Modine Technical Service Bulletin

Subject: Clearance to Combustibles Number Understated on Infrared Serial Plates Date: Oct 2016 To: Modine Sales Representatives and Distributors

Affected Models: Low Intensity Infrared 150 MBH input and above (TLP/RLP, MV/RV, MVM/RVM) High Intensity Infrared 84 MBH input and above (MT/RT, OSY)

Example Serial Plate:

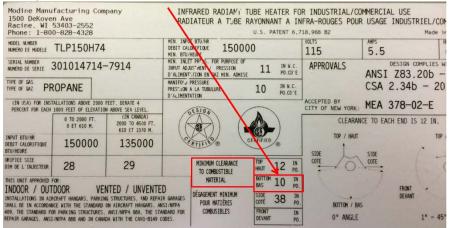
It has come to our attention that clearance to combustibles numbers were printed incorrectly on the serial plates of certain Modine Infrared Products. Specifically three-digit Clearance to Combustibles numbers were truncated to 2 digits. As an example, 106" became 10" when it was printed on the serial plate (see below).

Affix the additional label adjacent to the existing serial plate (labels are enclosed). Our records indicate some of these affected infrared units were shipped into your territory. See attached list. You may send labels to those customers with affected units or provide Modine a list and we will send a notification and labels.
